PROPOSED CONTRACT CHANGE

Contract No. 1252 Tunnels Date 03/01/2013
 PCC No. 1252-10 (Revision 01)
 PCC Title Relocation of TBM Retrieval Shaft

Description of PCC:

Project Name
THE PALACE AT WASHINGTON SQ

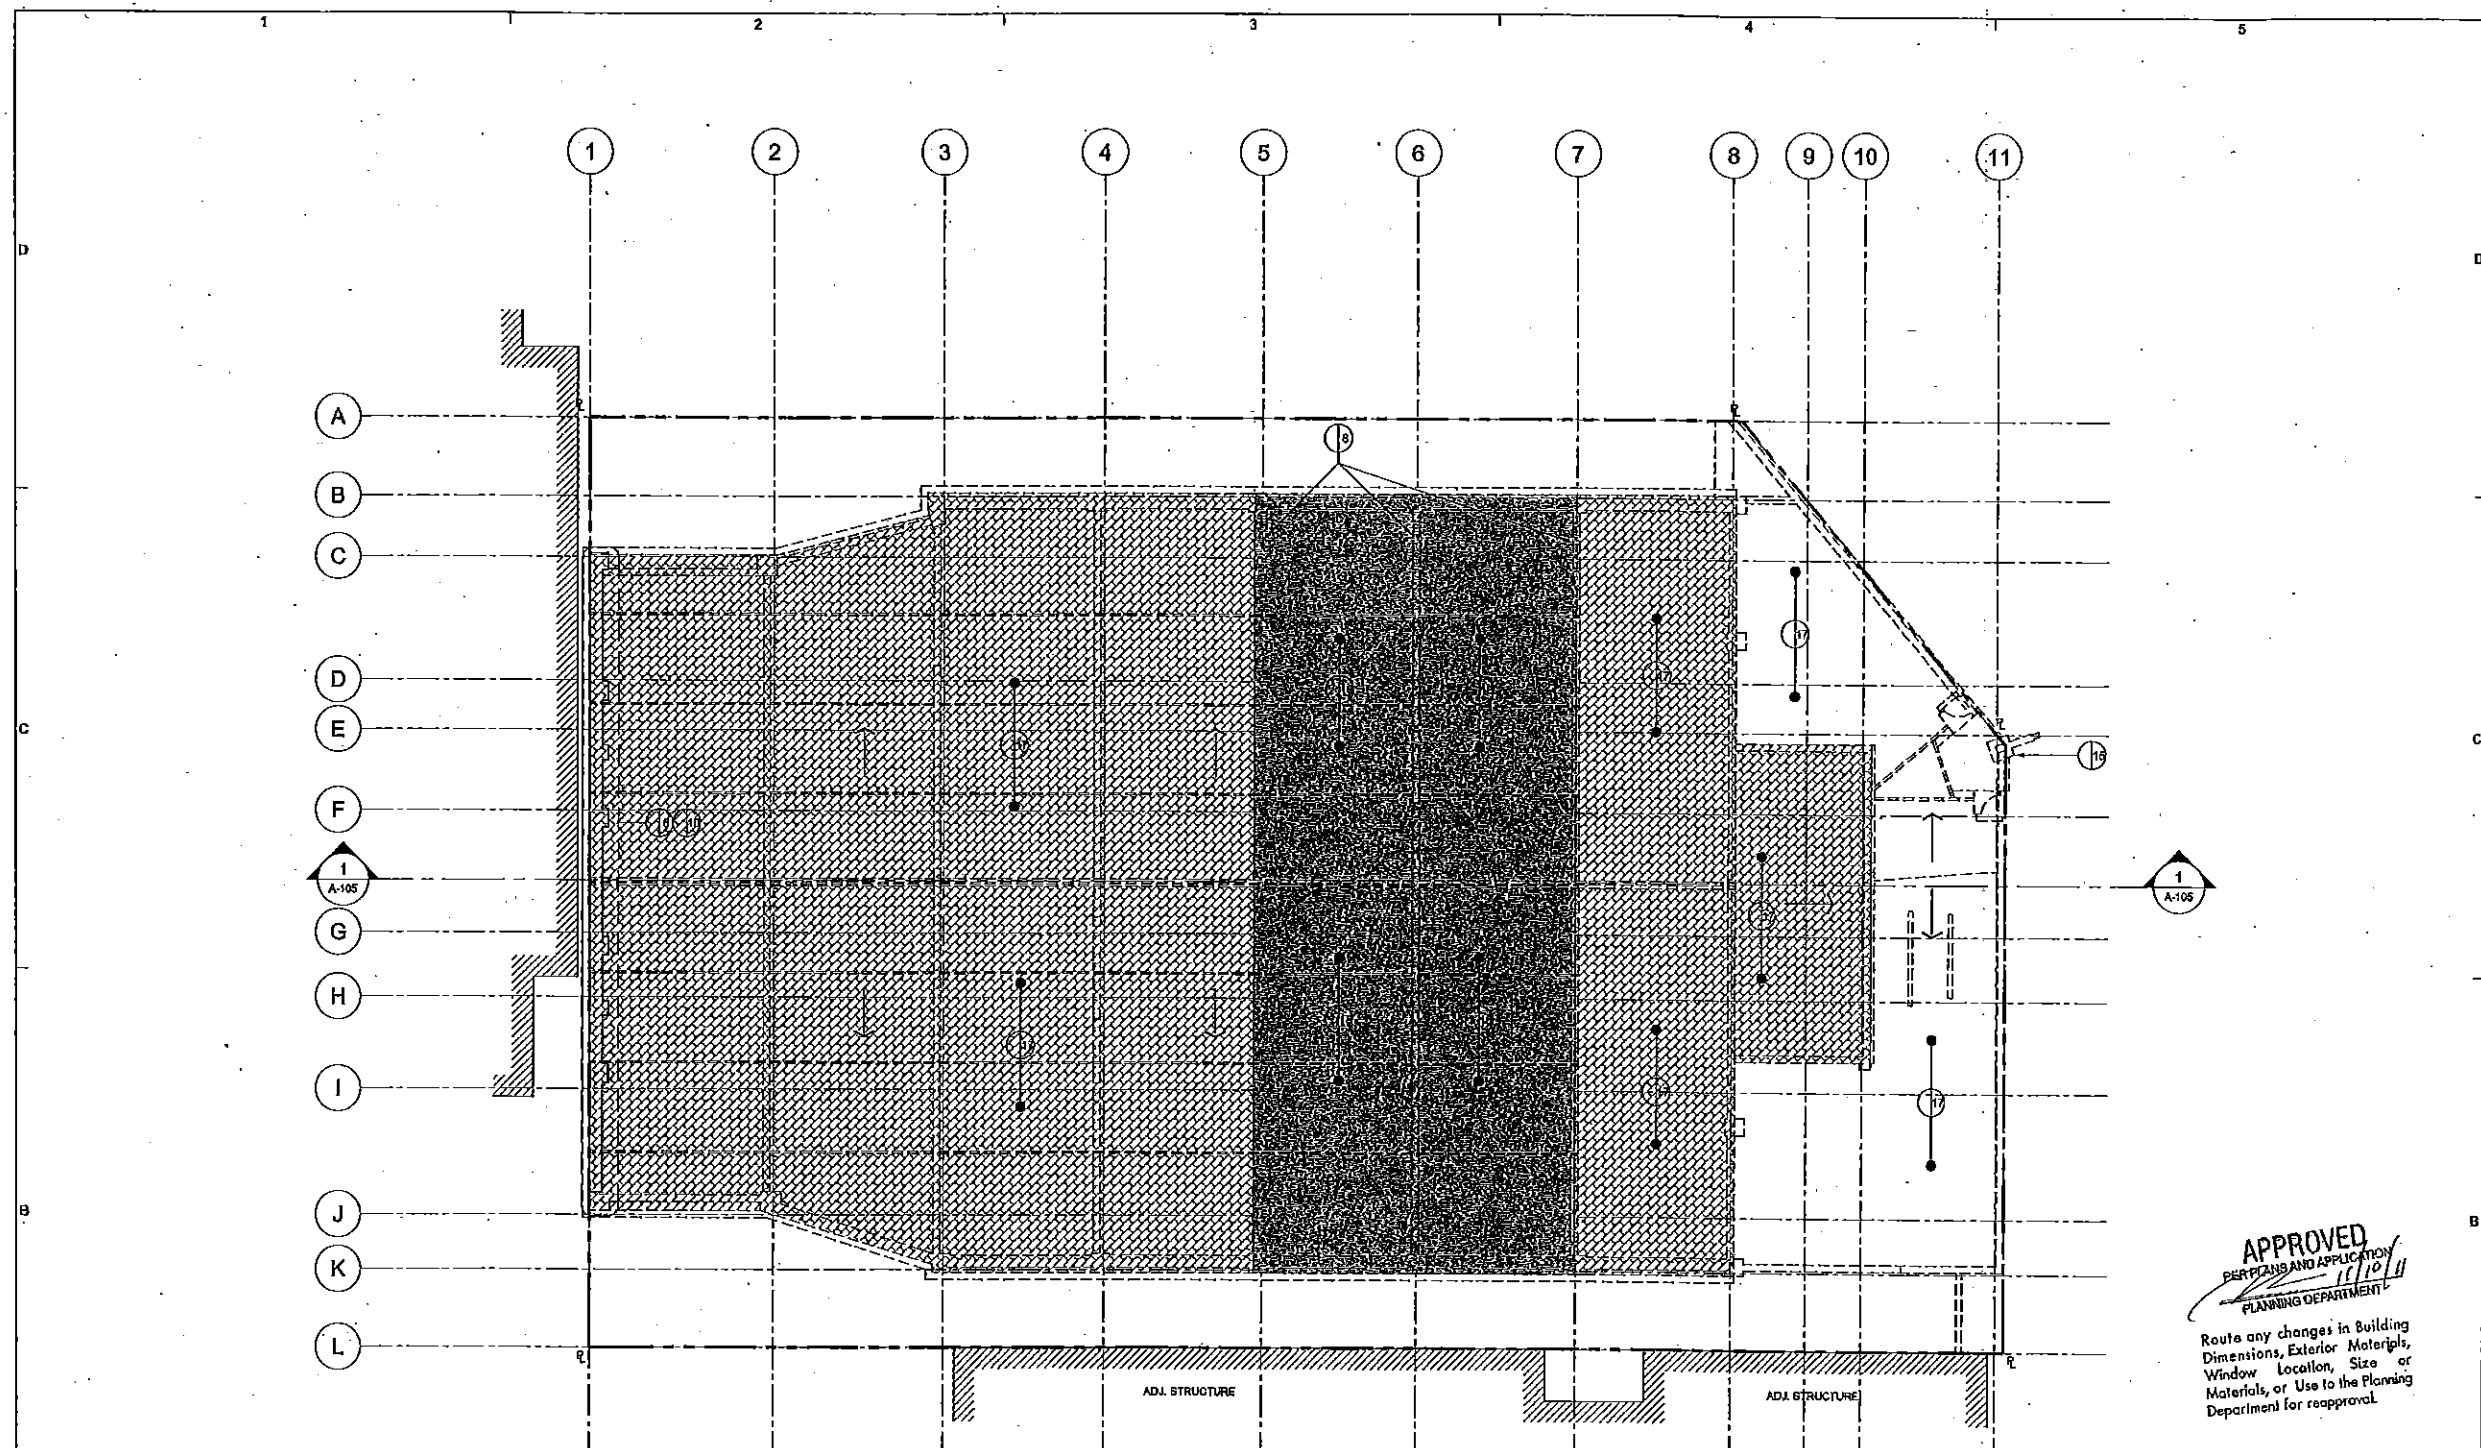
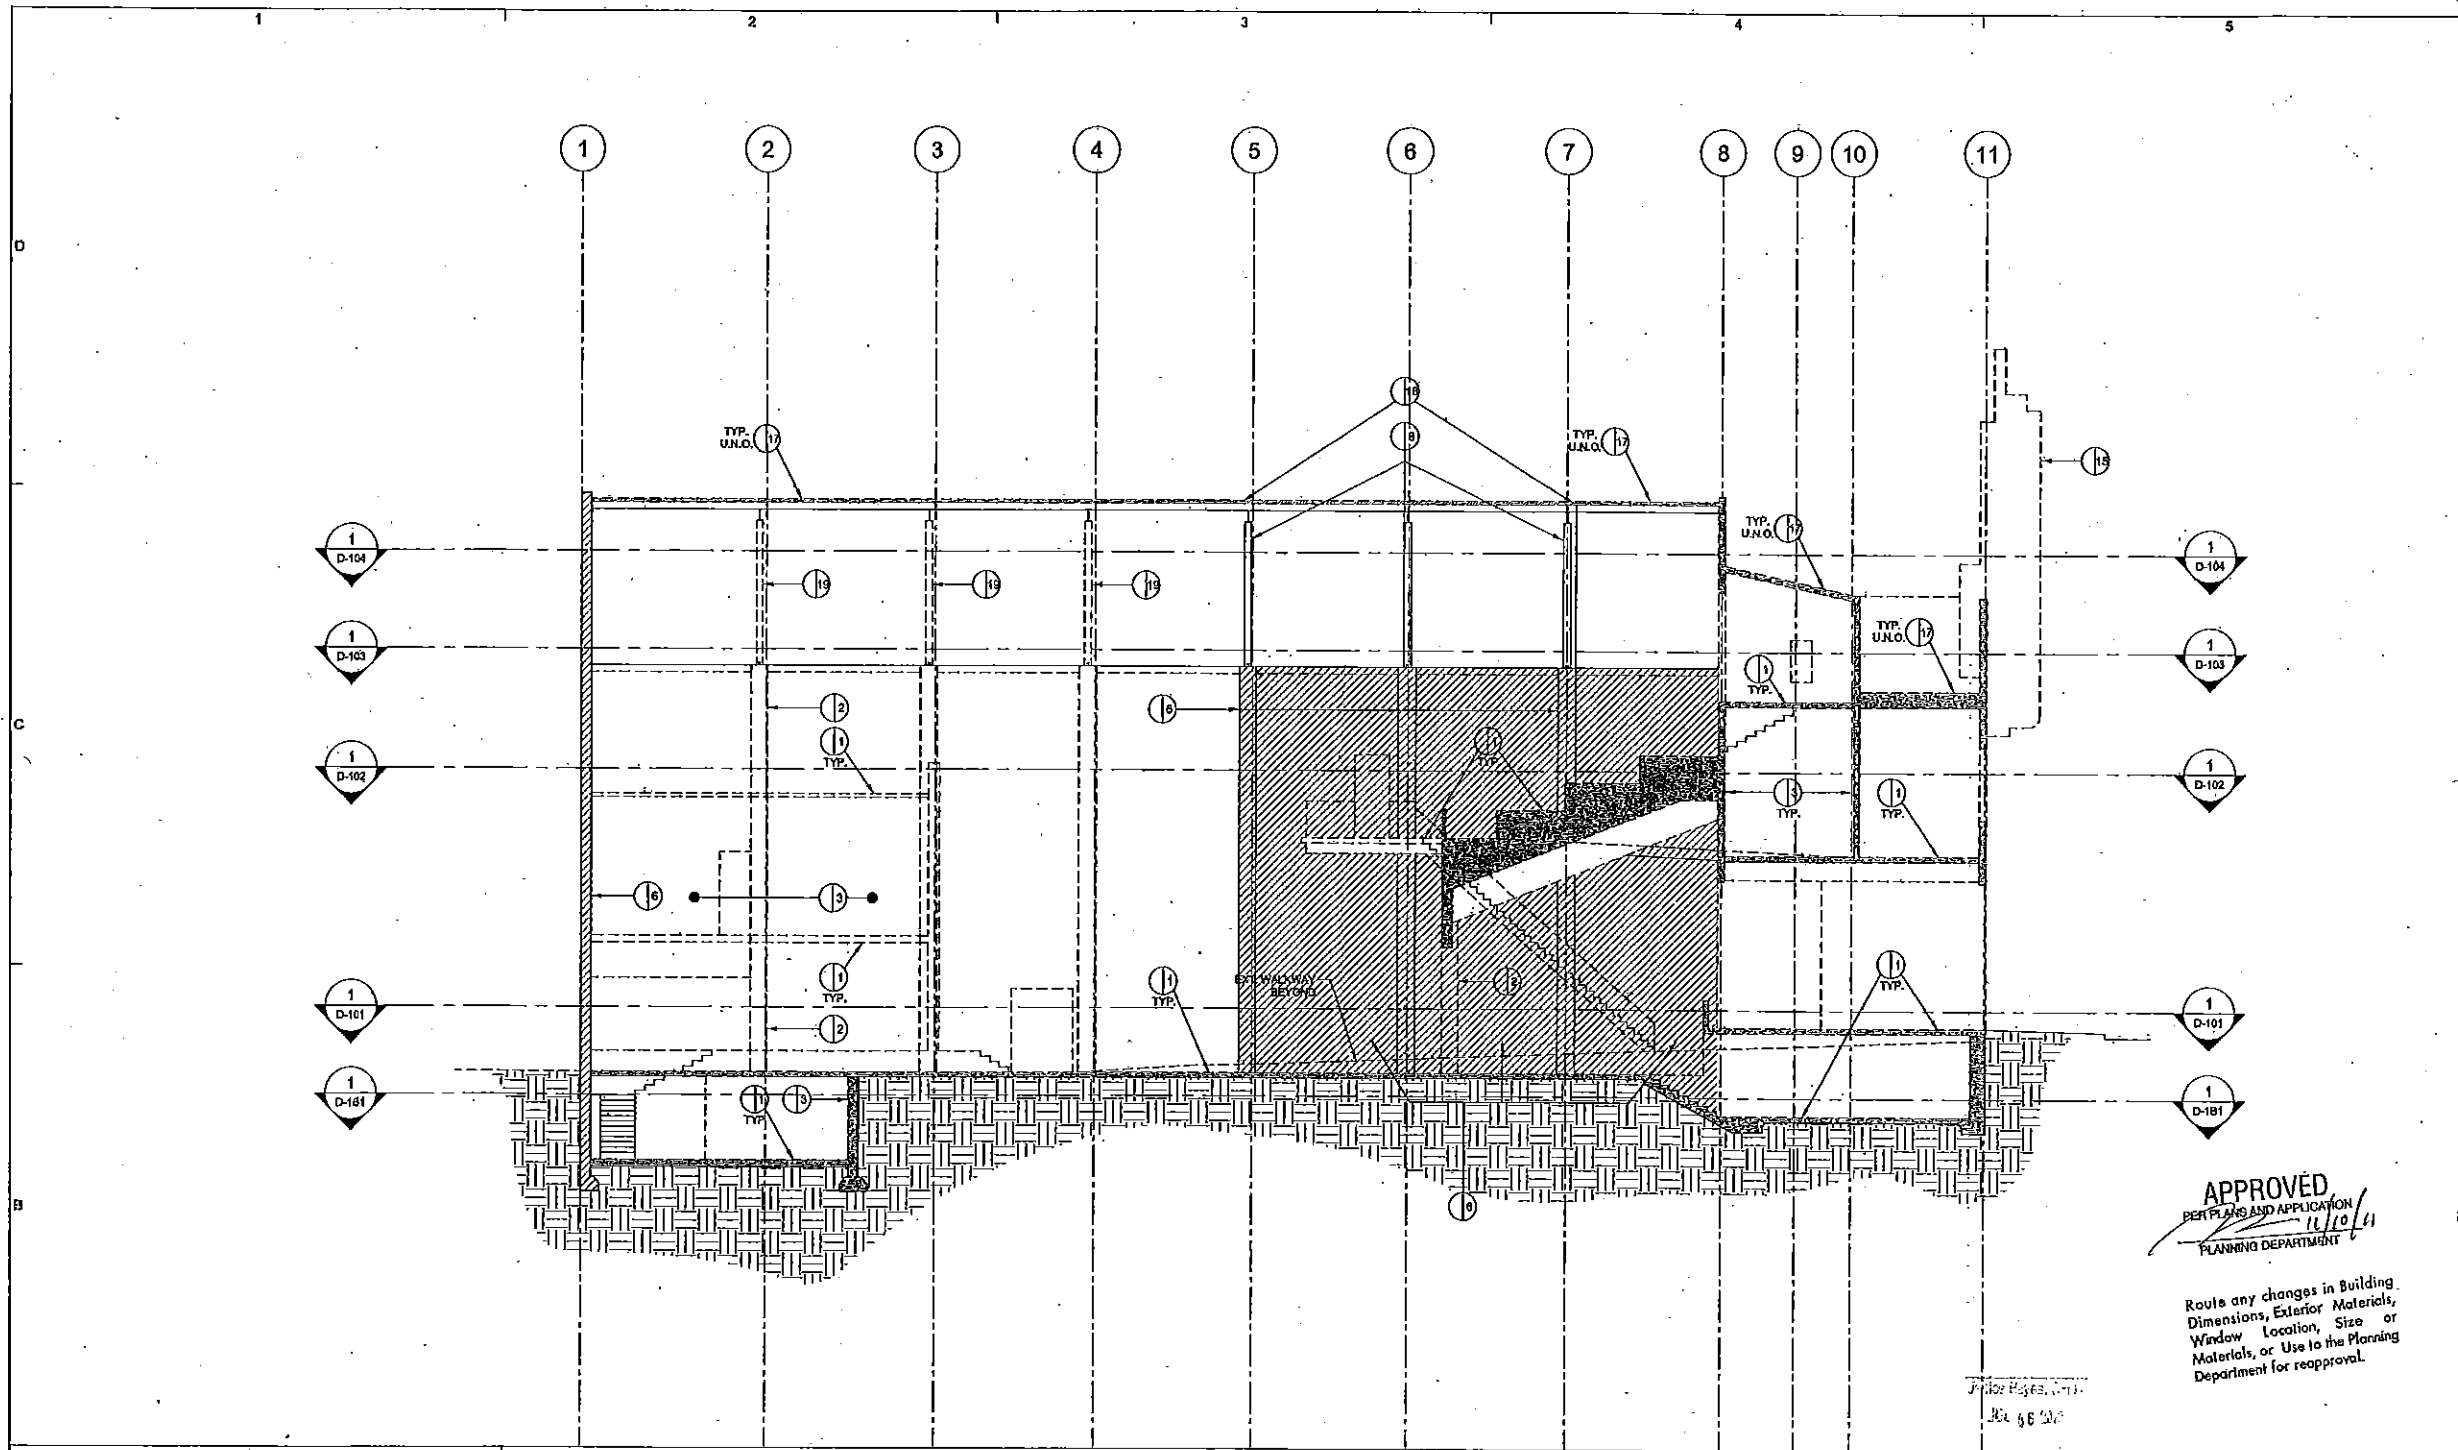
3. Design a demolition plan and demolish existing building at 1731-1741 Powell Street. Demolition to include entire building; roof trusses and perimeter walls are not to be retained as shown in the attached representative Demolition Drawings. Note: Below grade structures required for support of adjacent structures to be left in place.
